**HUGHES
SERVICE INFORMATION
NOTICE**

NOTICE NO N-41 *

**SUBJECT: AC ENGINE MOUNTED FULL-FLOW OIL FILTER-
INSTALLATION, 269 SERIES HELICOPTERS**

**MODELS AFFECTED: All 269 Series Helicopters with Avco Lycoming O-360
or HIO-360 Aircraft Engines Installed**

Figure 1. Exploded View of Full-Flow Oil Filter Assembly

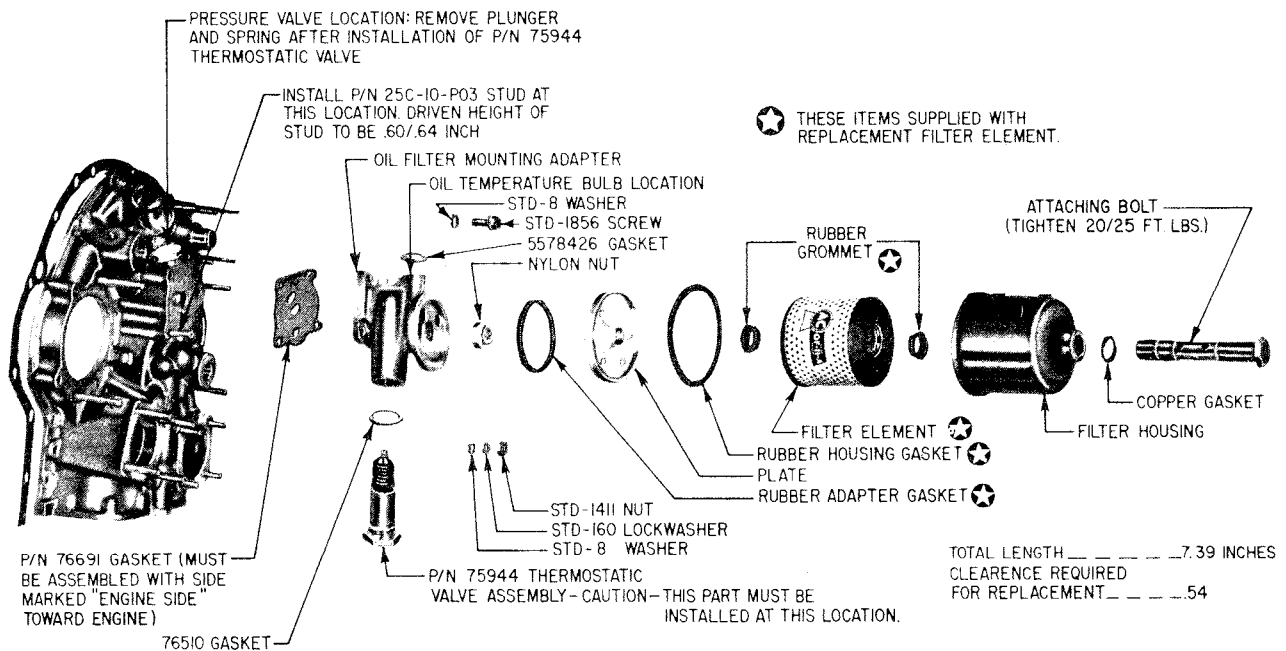
NOTE: Revision "A" to Service Letter No. L157 replaces AC 5579088 and AC 5579089 bolts with (3) STD-1856 self-locking screws; adds retapping instructions; replaces 74904 gasket with 76691 gasket; replaces AC 5579091 nut with STD-1411 nut; torque value 15 - 18 ft. lbs. changed to 20 - 25 ft. lbs.; torque value 60 in. lbs. changed to 75 in. lbs.; 69451 by-pass valve changed to 75944 by-pass valve; check for oil leaks added; revised figure 1 to reflect changes; changed 7.29 inch to 7.39 inch in figure 2; and revised lock-wiring in figure 2.
